1984 Corvette: Recall: Product Safety Campaign 84C25 Rear Axle Differential Cross Shaft

Subject: Product Safety Campaign 84C25 Rear Axle Differential Cross Shaft

Model and Year: 1984 Chevrolet Corvette Models

Bulletin No: 84C25

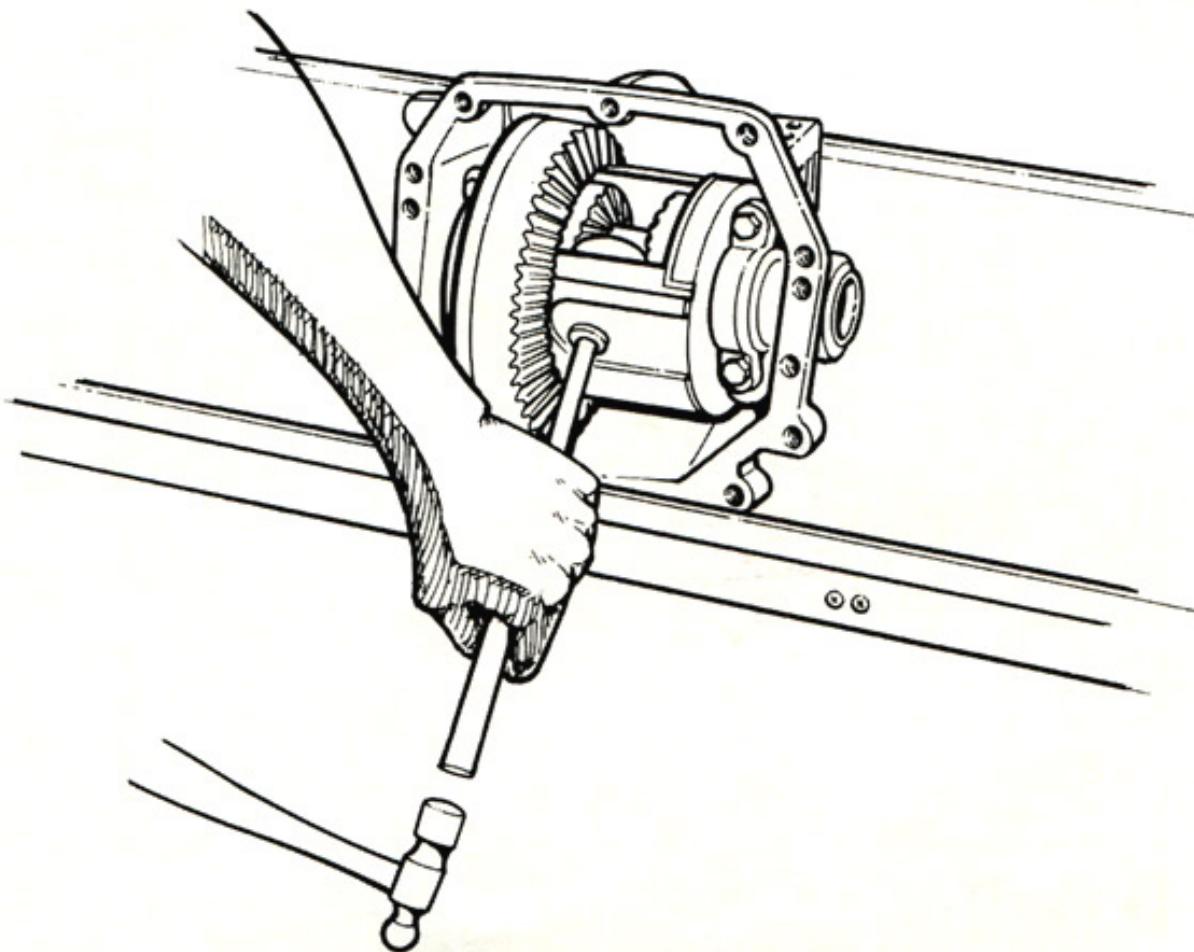
5. Rotate case assembly to position illustrated in Figure 1. With appropriate size drift and small mallet, lightly tap on cross shaft to determine if movement of shaft can be achieved.

FIGURE 2

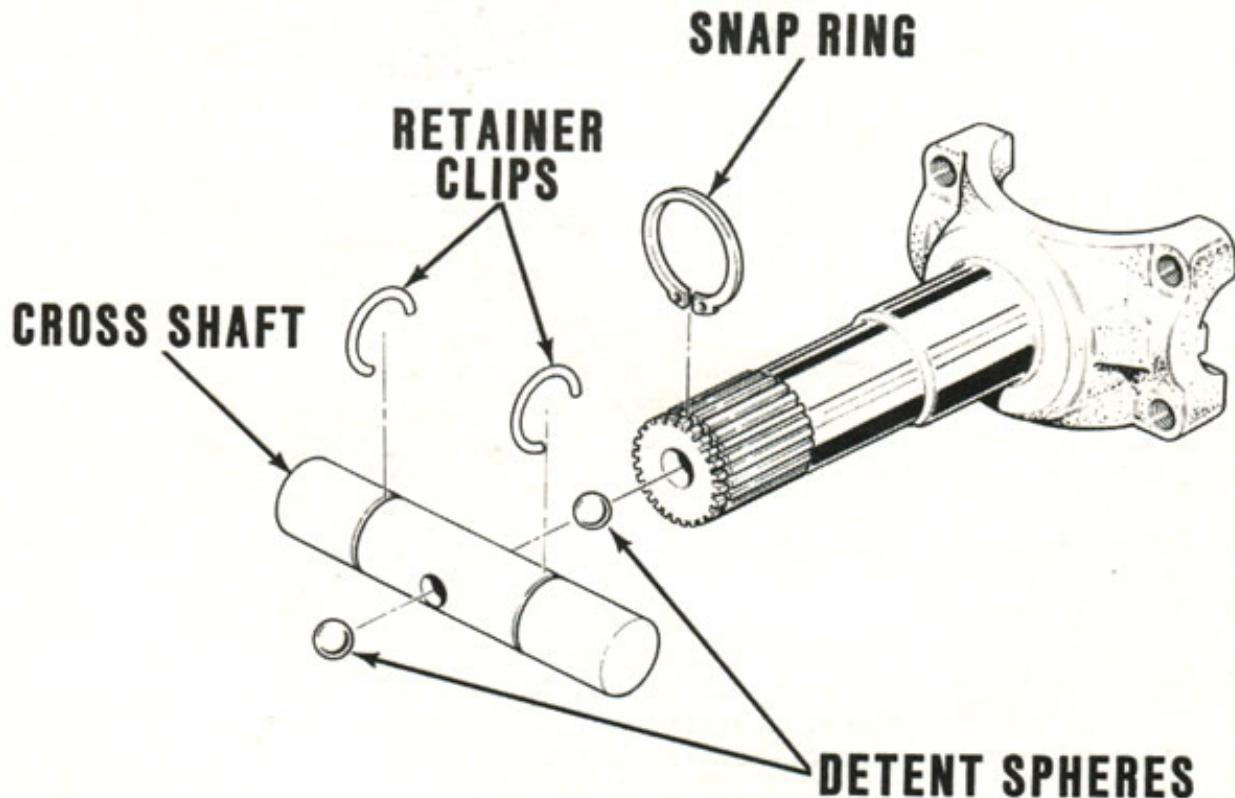
Tap cross shaft inboard approximately $1\frac{1}{4}$ inches and rotate case 180° . Utilizing vise grips and a back and forth motion, remove shaft. Install new cross shaft insuring detents in the shaft are positioned properly to accept spheres (balls) to be installed between shaft and output yokes as illustrated in Figure 2.

Remove case assembly from carrier following appropriate procedure in 1985 Corvette Shop Manual. Press existing cross shaft out of case and install new cross shaft insuring detents in the shaft are positioned properly to accept spheres (balls) to be installed between shaft and output yokes as illustrated in Figure 2. Reinstall case assembly following appropriate 1985 Shop Manual procedure.
